Metro Outer Joint Development Assessment Panel Agenda

Meeting Date and Time: Friday, 6 October 2023; 9:30am
Meeting Number: MOJDAP/277
Meeting Venue: Electronic Means

SPECIAL INDUSTRIAL DEVELOPMENT
Lot 1728 (No 60) Office Road
EAST ROCKINGHAM WA
for
Lupomar Pty Ltd

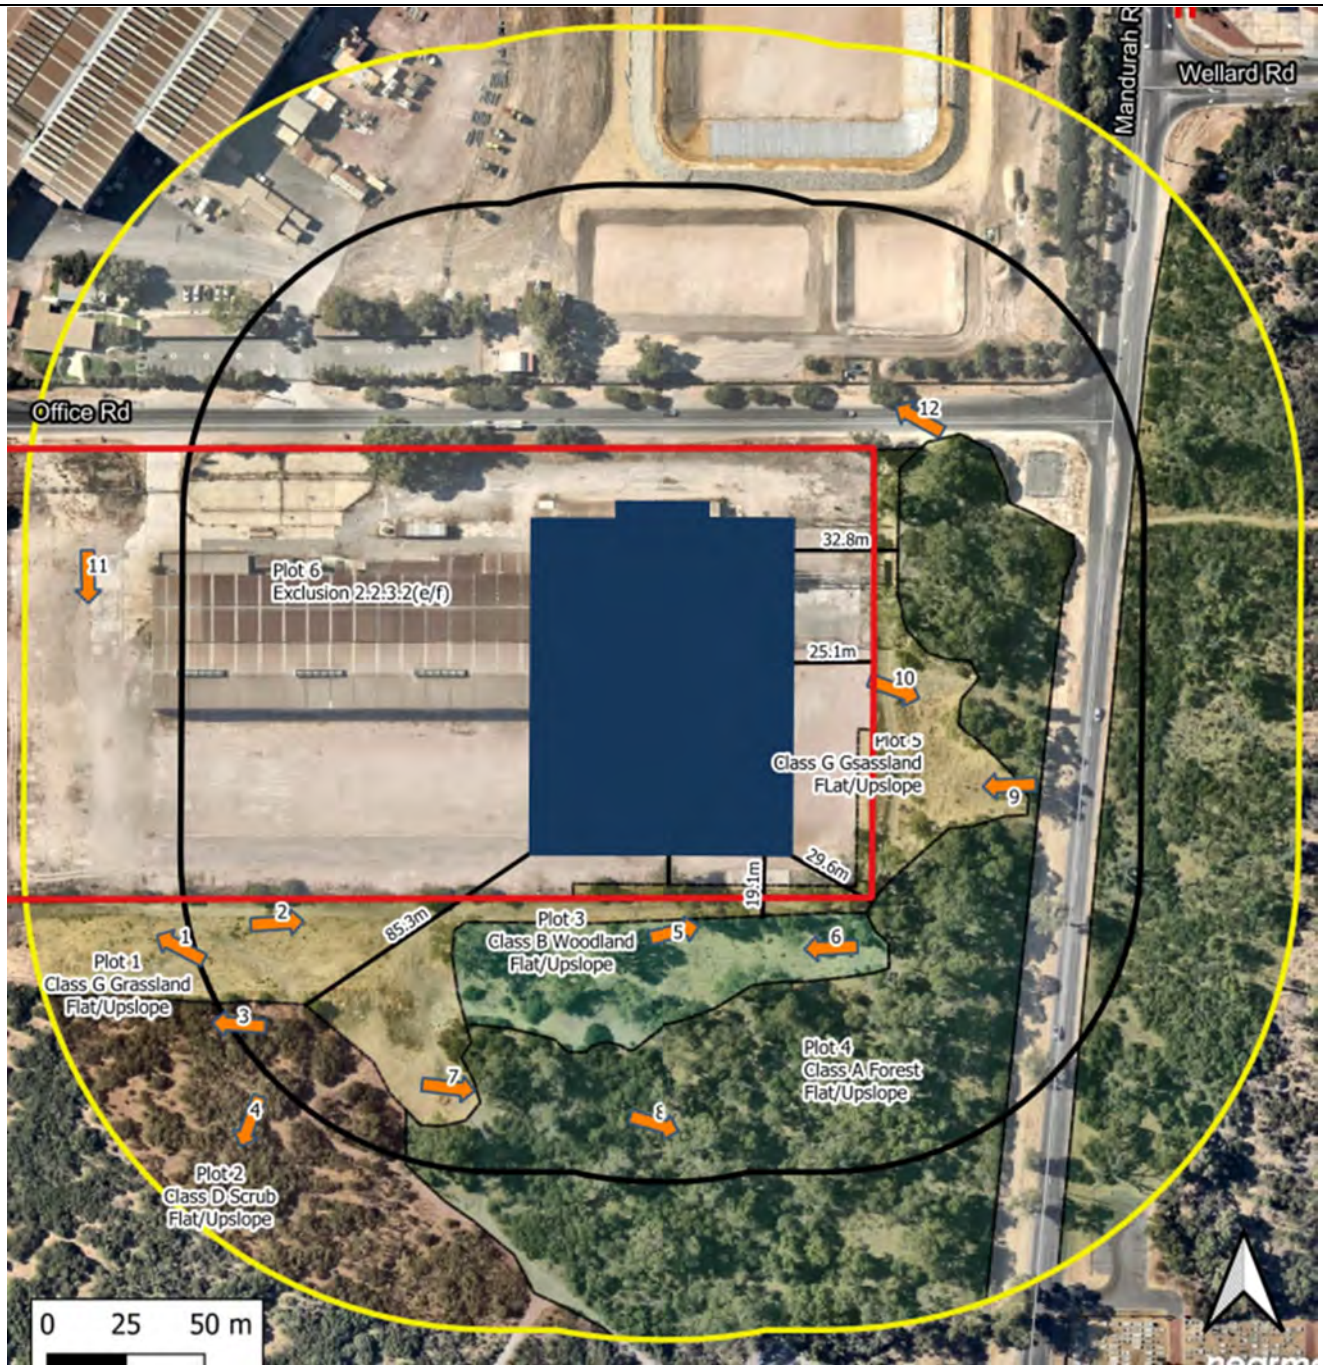
The vegetation classification map (Figure 5) seems to show vegetation excluded outside the lot boundary on the western and southern sides and a narrow strip along the eastern boundary.
There is no evidence to support that these areas would be managed to low threat in accordance with AS3959 in perpetuity.</td><td>Modification to proposal and/or the BMP is required.</td></tr>
</table>
</td></tr>
</table>
